Executive Director's Recommendation

Commission Meeting: September 12, 2013

PROJECT THE SMITHSONIAN INSTITUTION NATIONAL MUSEUM OF AFRICAN AMERICAN HISTORY AND CULTURE National Museum of African American History and Culture Constitution Avenue and Madison Drive between 14th and 15th Streets, NW Washington, DC	NCPC FILE NUMBER 6331
	NCPC MAP FILE NUMBER 1.42(64.00)42823
	APPLICANT'S REQUEST Approval of final revised site plans
	PROPOSED ACTION Approve
SUBMITTED BY Smithsonian Institution	ACTION ITEM TYPE Consent Calendar
REVIEW AUTHORITY PL 108-184 per 40 U.S.C. § 8722(b)(1) and (d)

PROJECT SUMMARY

Figure 7: Site plan and security wall details

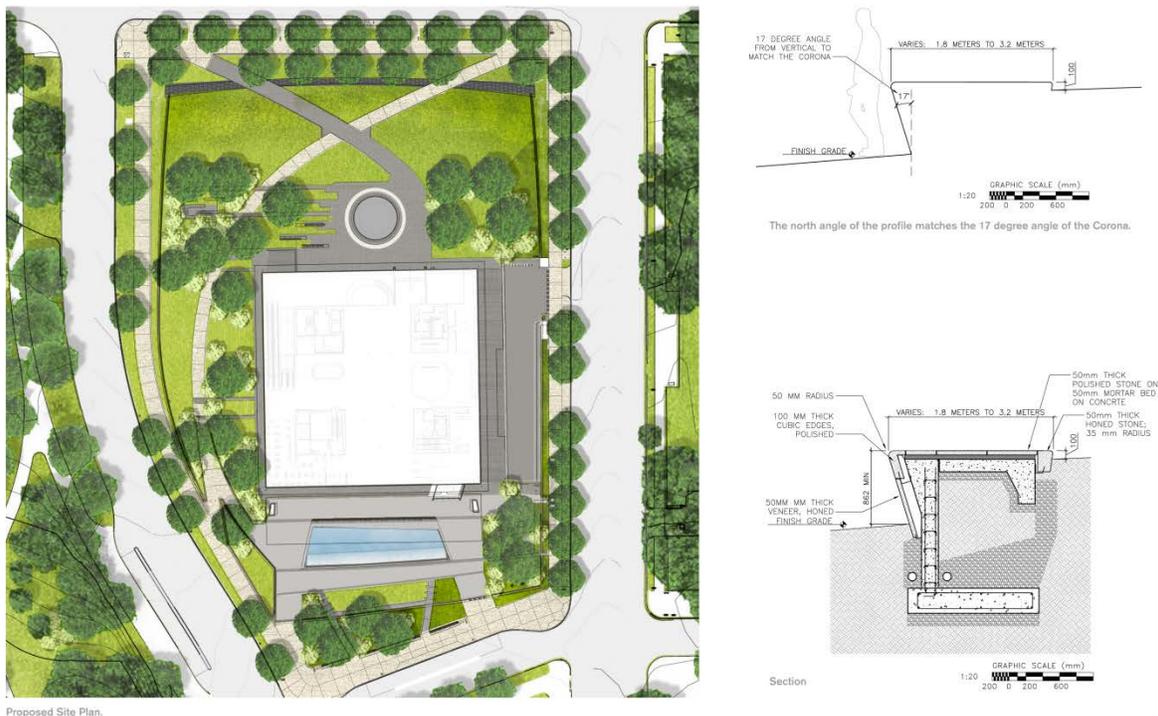
The North Entry has been re-designed to reinforce the threshold to the site and enhance the experience of rising up and reflecting on history as visitors enter the site. The rising path brings visitors into the world of the museum where the Oculus acts like a beacon in the landscape signaling entry and a place of welcome.

The landscape has been designed to fit into the overall context of the Mall as part of a composition that frames the Washington Monument. At the north edge, the design holds several alignments that reinforce the character along Constitution Avenue. The sidewalks along the north edge just north of the NMAAHC security wall align with the security walls at NMAH to the east. The sidewalks & planters in the design align with the adjacent sidewalks and planters to the east & west. The double allée of trees along NMAAHC's north border align with the existing double allée of trees at the north edge of the Washington Monument grounds, and the trees at NMAH to the east.
